SUBMITTAL DRAWING

STONE & WEBSTER ENGINEERING CORPORATION

NINE MILE POINT NUCLEAR STATION - UNIT 2

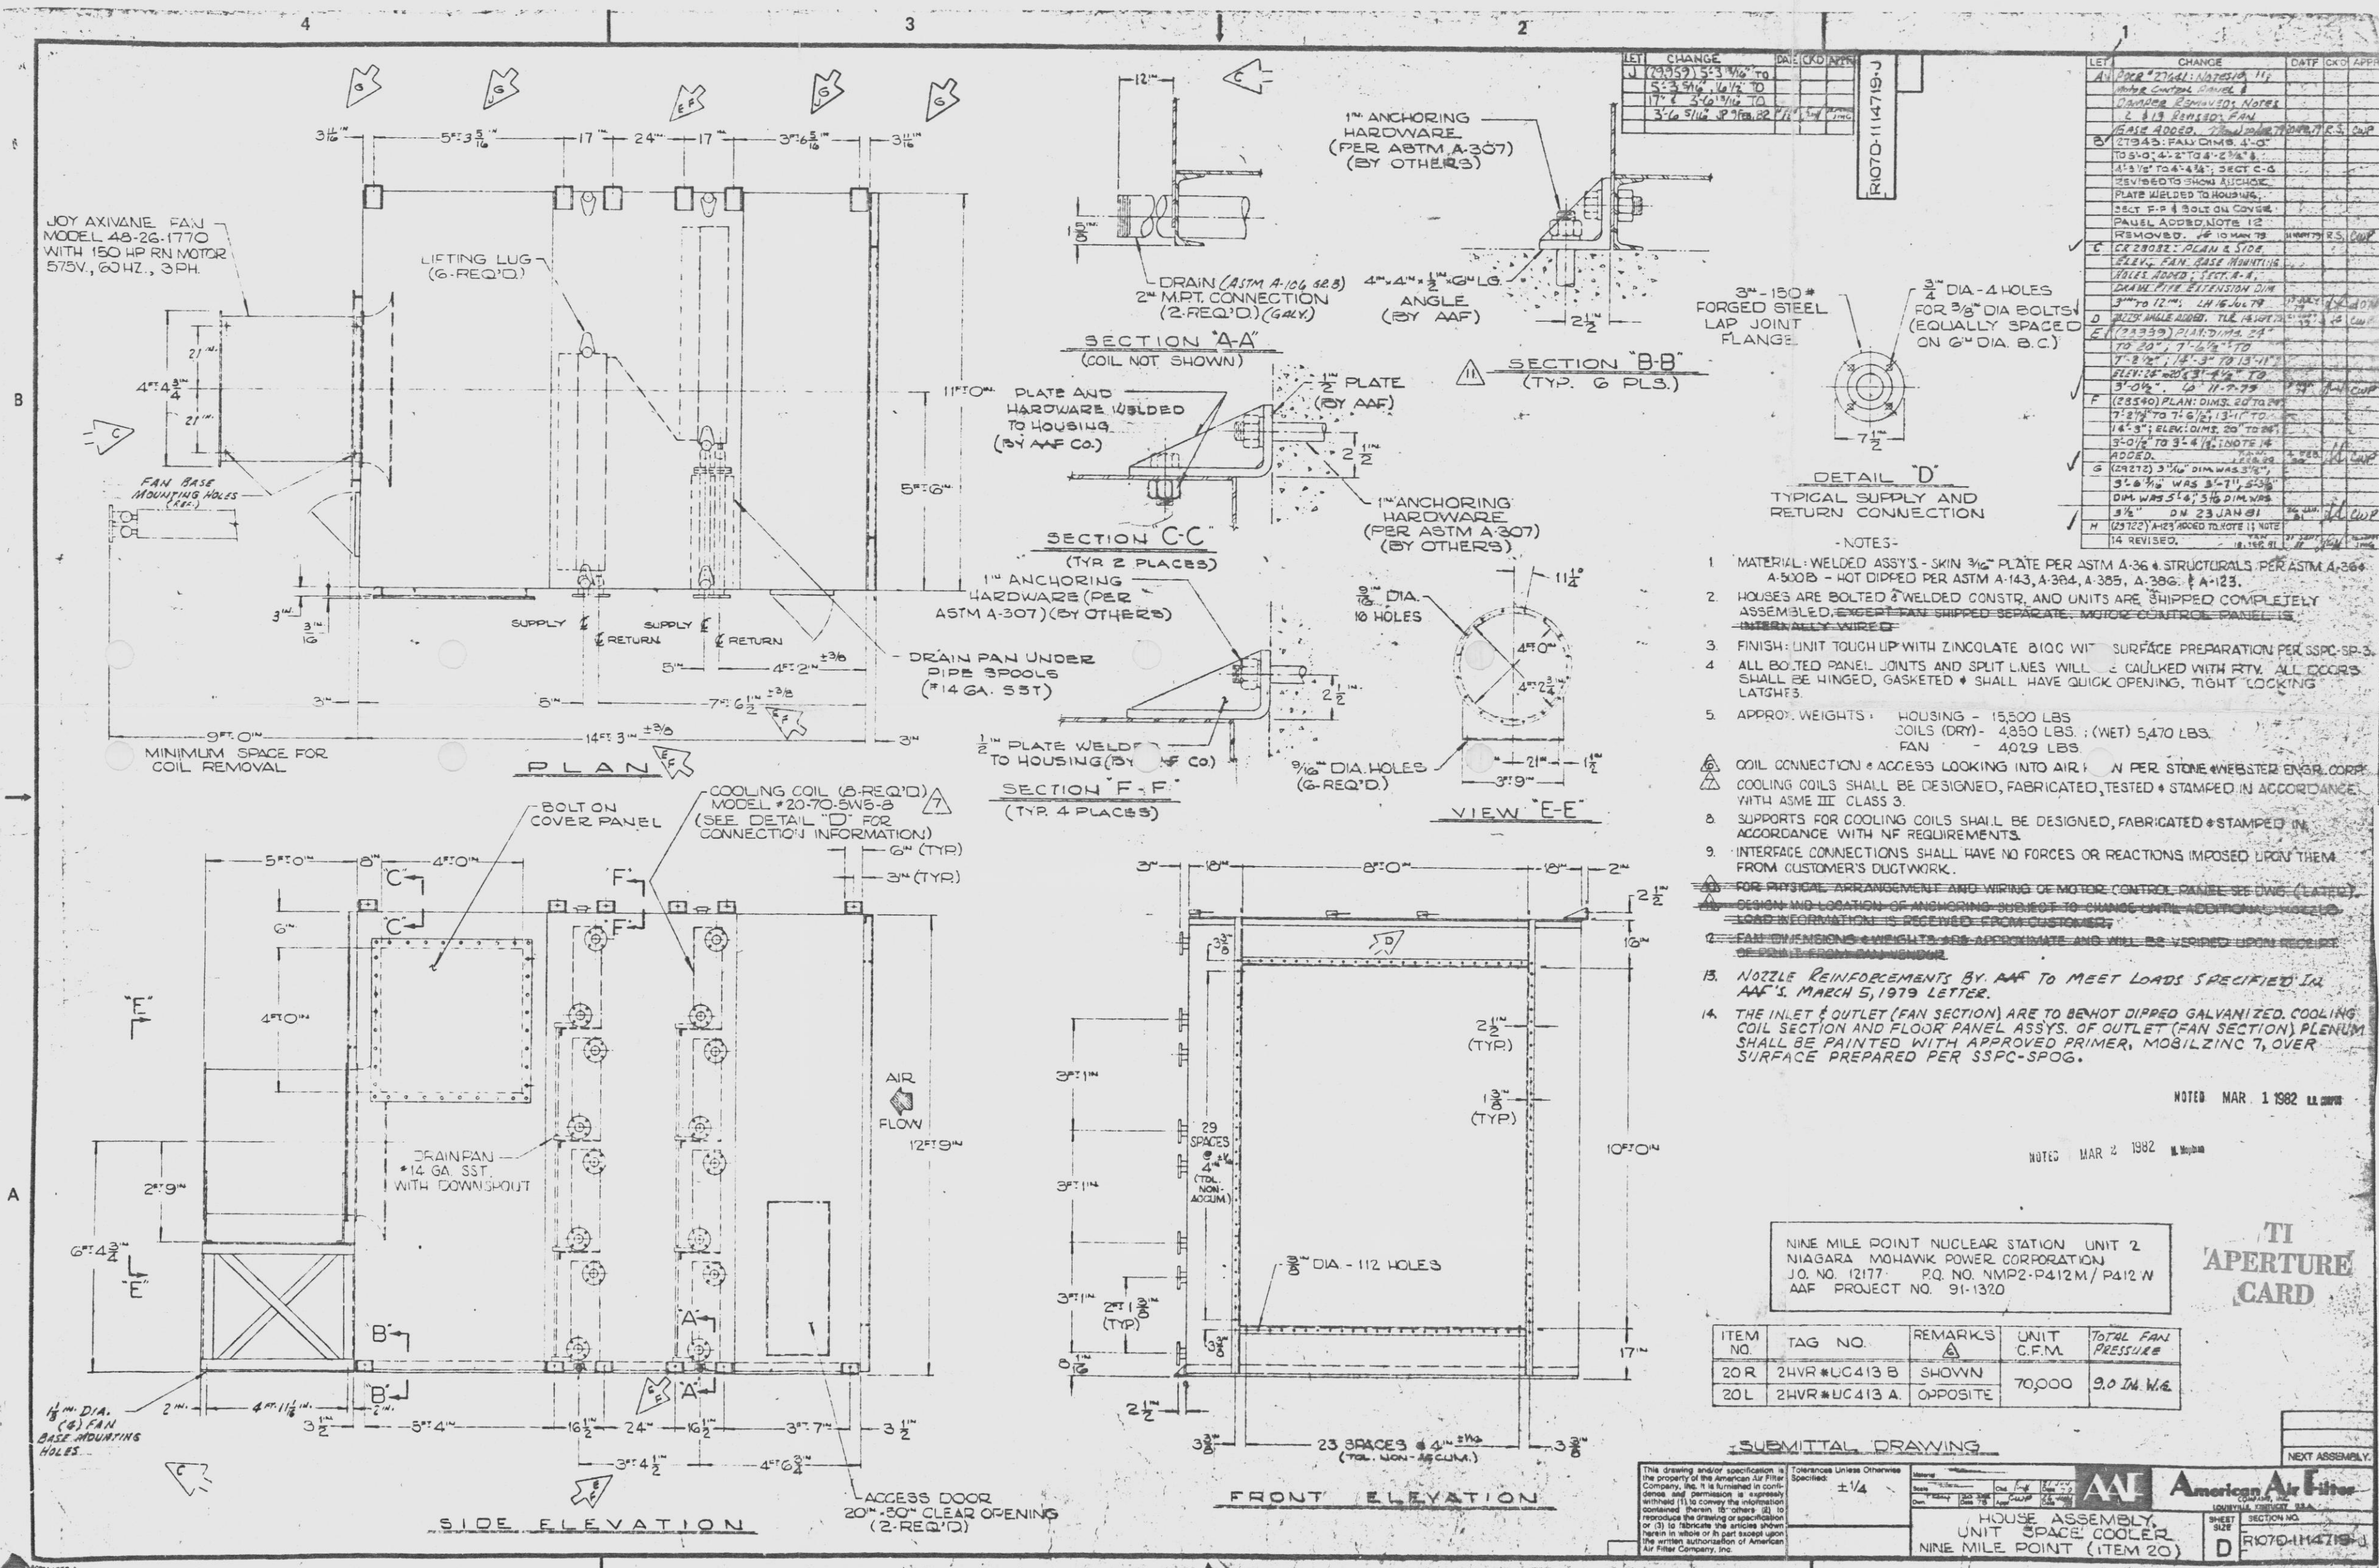
APPROVED AS REVISED
